DEVELOPMENT APPLICATION ASSESSMENT REPORT

Application Number:	DA2018/2015
----------------------------	-------------

Responsible Officer:	Catriona Shirley
Land to be developed (Address):	Lot 100 DP 1250837, 163 Riverview Road AVALON BEACH NSW 2107
Proposed Development:	Alterations and Additions to a dwelling house and construction of a swimming pool
Zoning:	E4 Environmental Living W1 Natural Waterways
Development Permissible:	Yes
Existing Use Rights:	No
Consent Authority:	Northern Beaches Council
Delegation Level:	NBLPP
Land and Environment Court Action:	No
Owner:	Geoffrey Howard Lee Yin Lee
Applicant:	Turnbull Planning International Pty Ltd

Figure 1: Existing and proposed roof height

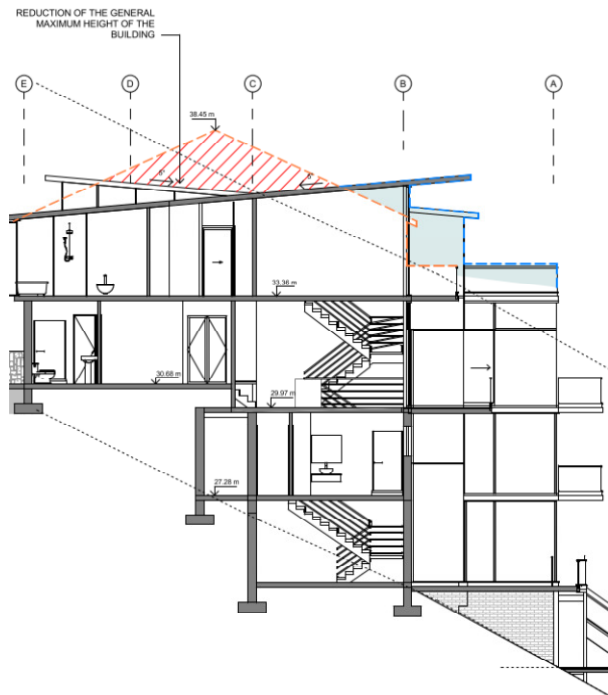
Notwithstanding, the overall height of the development is below the existing RL38.45 at RL37.09 (reduced by 1.36m as shown in Figure 1 below) due to the change in the roof design, and continues to be representative of a four (4) storey development when viewed from properties to the north and west and a two (2) storey development when viewed from the upslope of Riverview Road.

The non-compliance is located at the western edge of the roofline and of the balcony of Level 4 and the additional balconies of Level 2/3. It is noted that a reduction to the height would not achieve compliance and will not reduce the scale of the building to any significant extent such that it would appear as smaller than the existing.

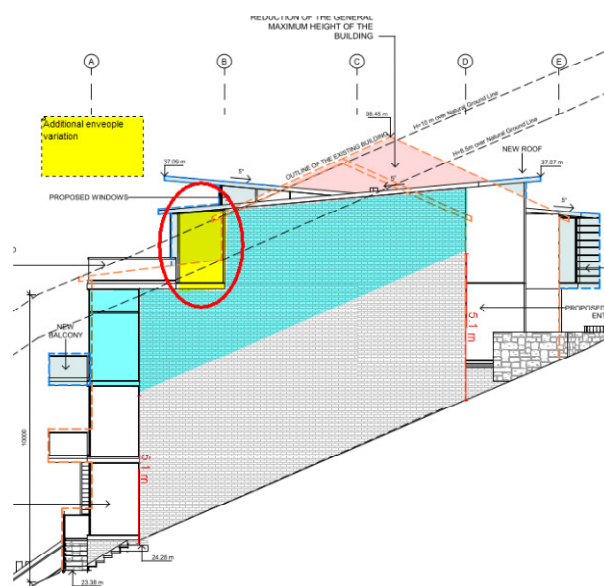
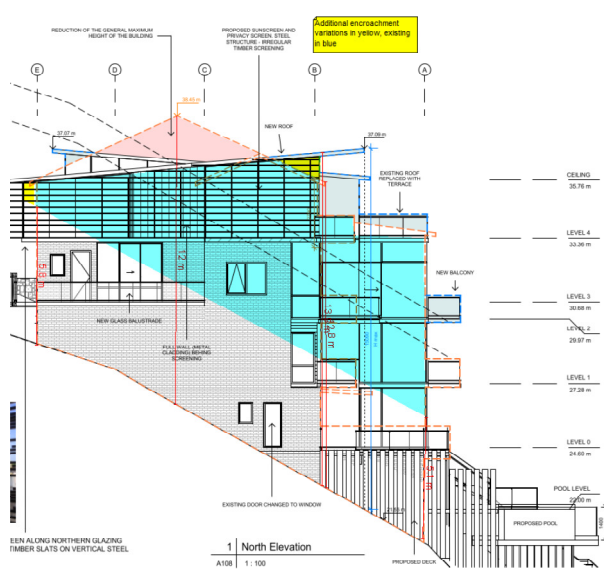
The existing dwelling exhibits significant non-compliance with the side building envelope requirements. The proposed development involves additional areas that protrude beyond the existing envelope breach.

In both instances, the non-compliances reflect the transitions within the existing ground line. The resulting built form is not considered unreasonably bulky or dominant and will be suitably in scale with the large trees that dominate the site as shown by Figure 2 and Figure 3 below.
